Project: Scanlon Creek NAtureCentre
2450 Line9
Bradford, ON

1. LANDSCAPE DRAWING REVISIONS

No.	Description	Date	By
5	ISSUED FOR ADDENDUM	2024-10-17	AM
4	ISSUED FOR TENDER	2024-09-19	AM
3	ISSUED FOR SPA	2024-08-02	AM
2	ISSUED FOR SPA/30% TECHNICAL REVIEW	2024-04-12	AM
1	ISSUED FOR DD PROGRESS	2024-02-08	AM

Drawing L-110 Landscape Plan - North

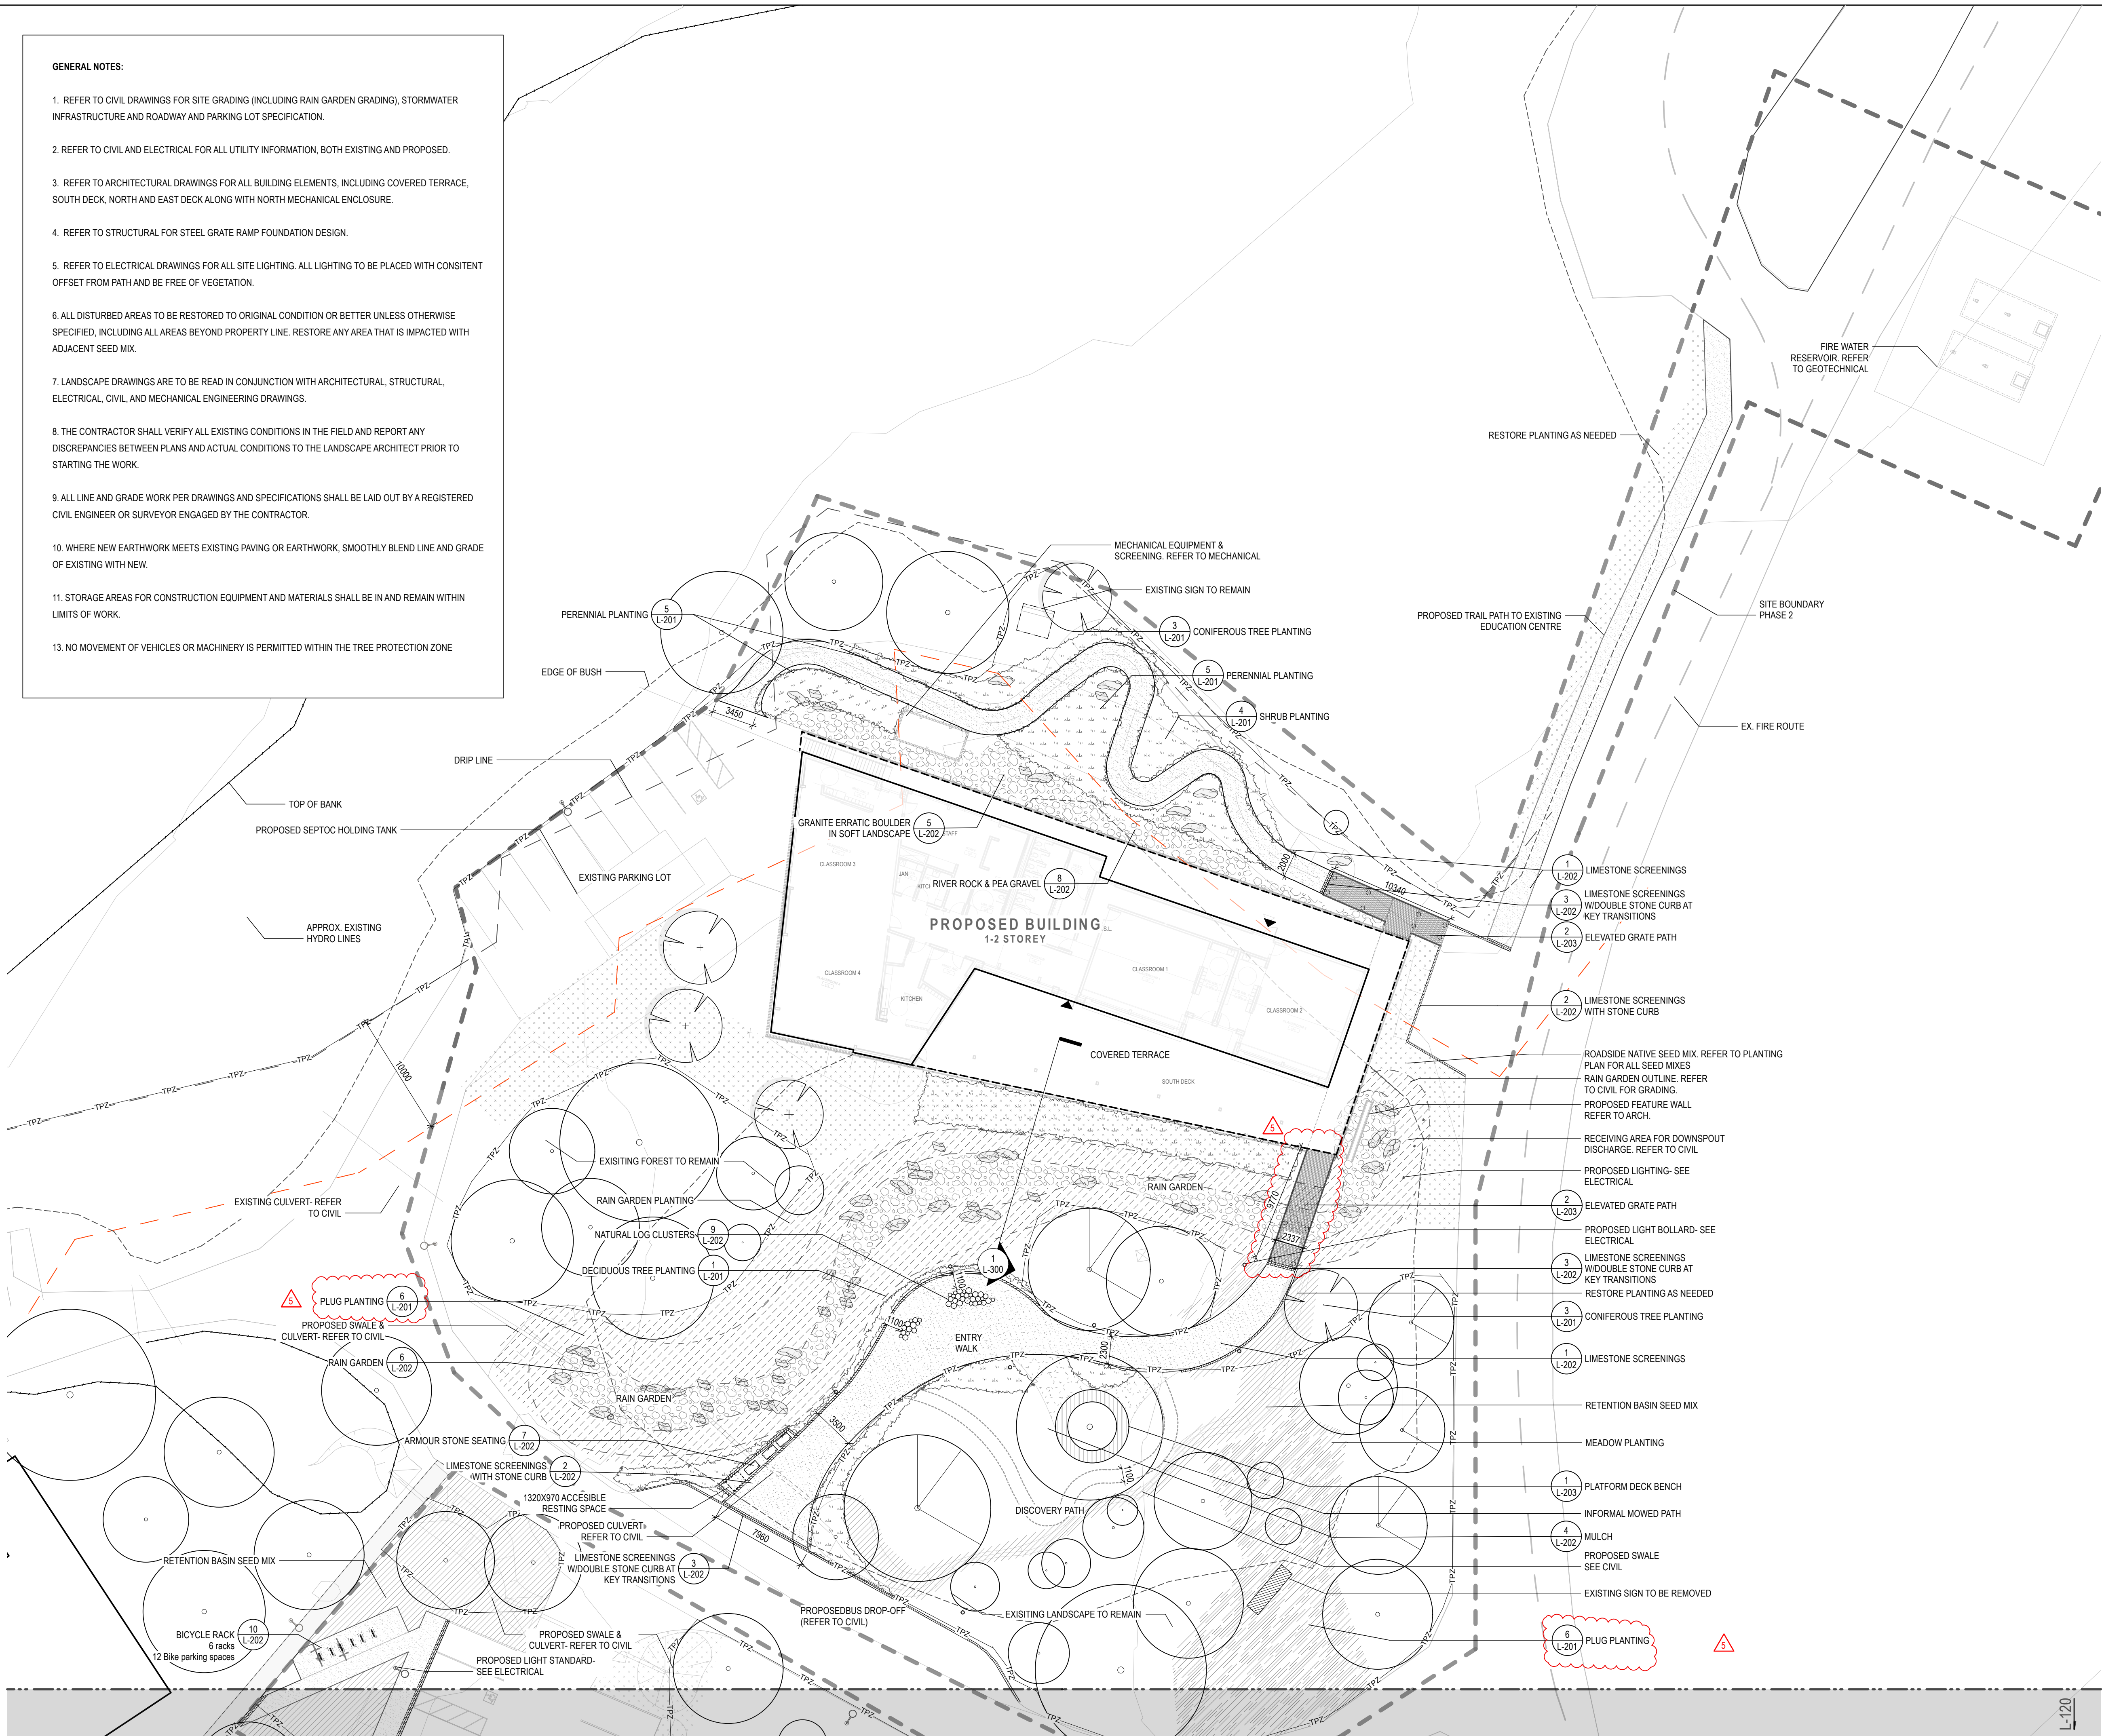
- a. **Revise** width of elevated grate path
- b. **Add** callouts for detail 6/ L-201 Plug Planting

5 PERENNIAL PLANTING

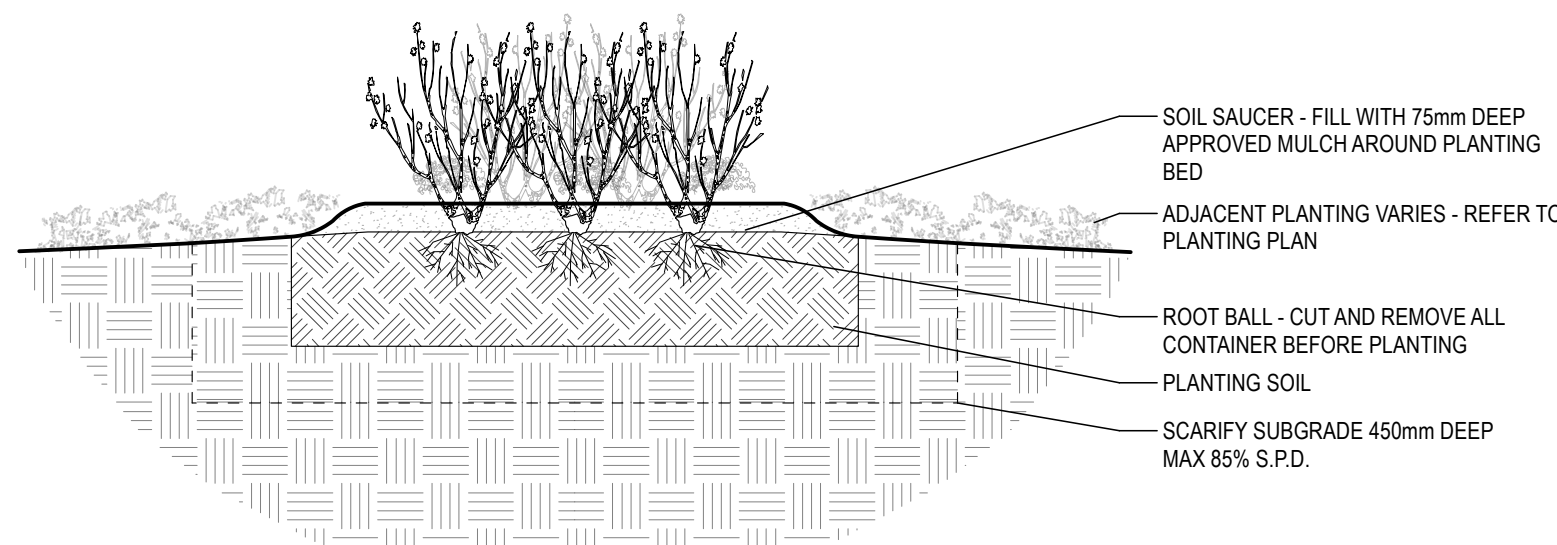
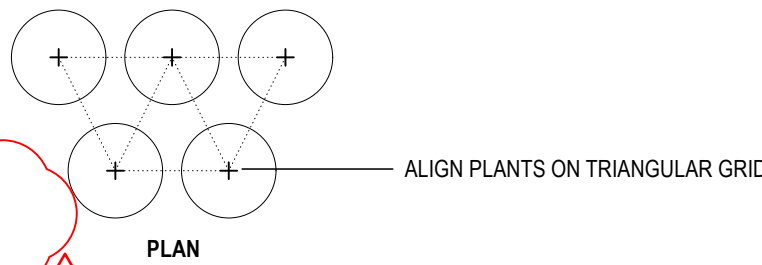
- a. **Revise** spacing note for detail 5 Perennial Planting
- b. **Add** detail 6 Plug Planting

2 LIMESTONE SCREENINGS WITH STONE CURB
1:10

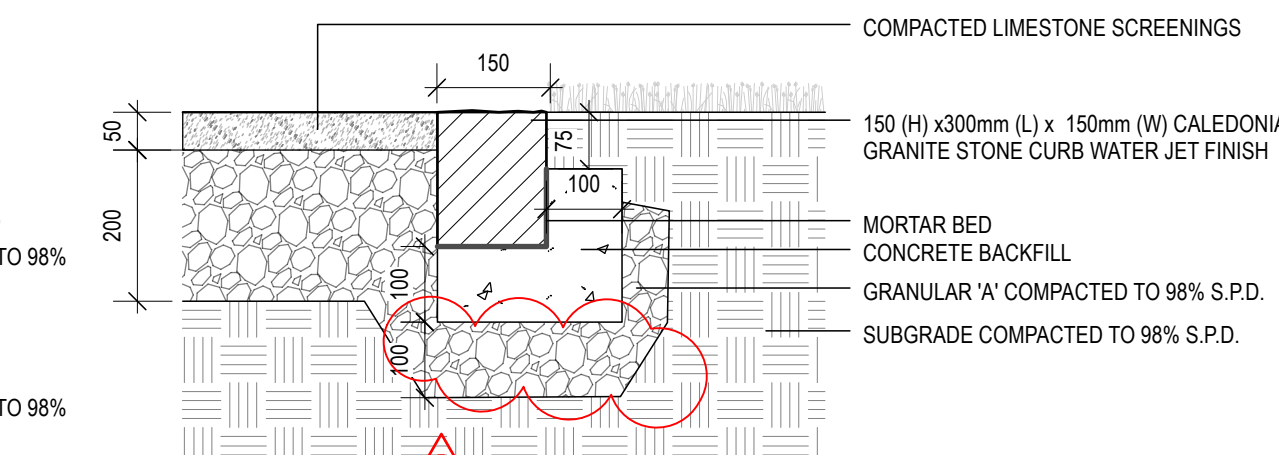
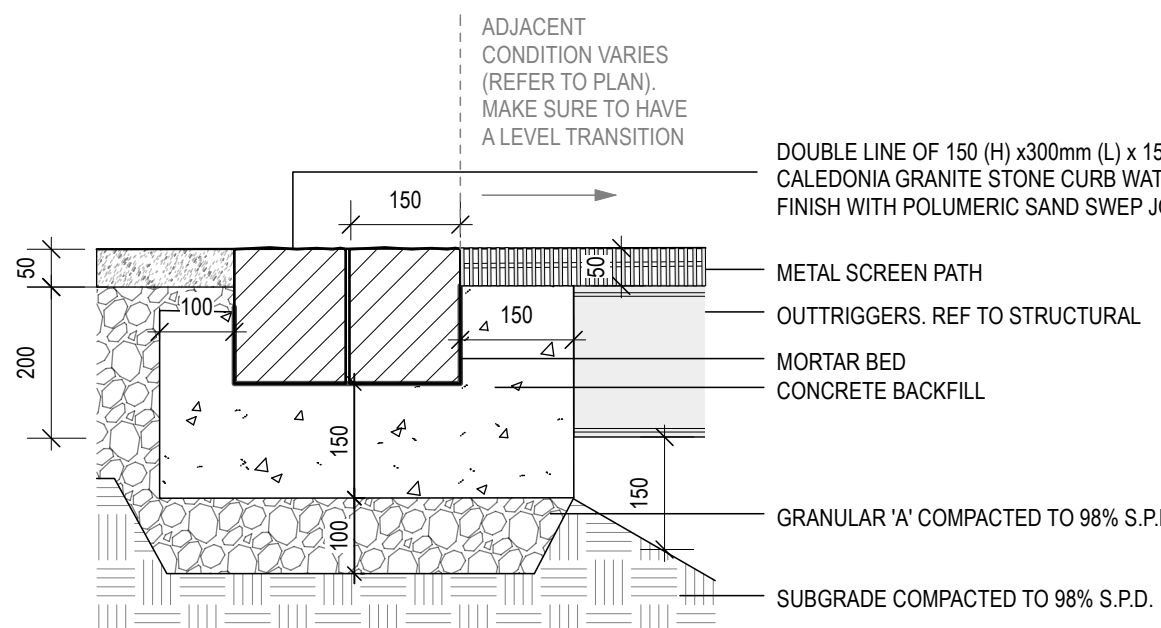
- a. **Revise** thickness of Granular 'A' for detail 2 (Limestone Screenings with Stone Curb)
- b. **Revise** detail 3 Limestone Screenings w/ Double Stone Curb at Key Transitions) to match structural outriggers.
- c. **Add** note "Planting soil per planting details" to detail 6 (Rain Garden)
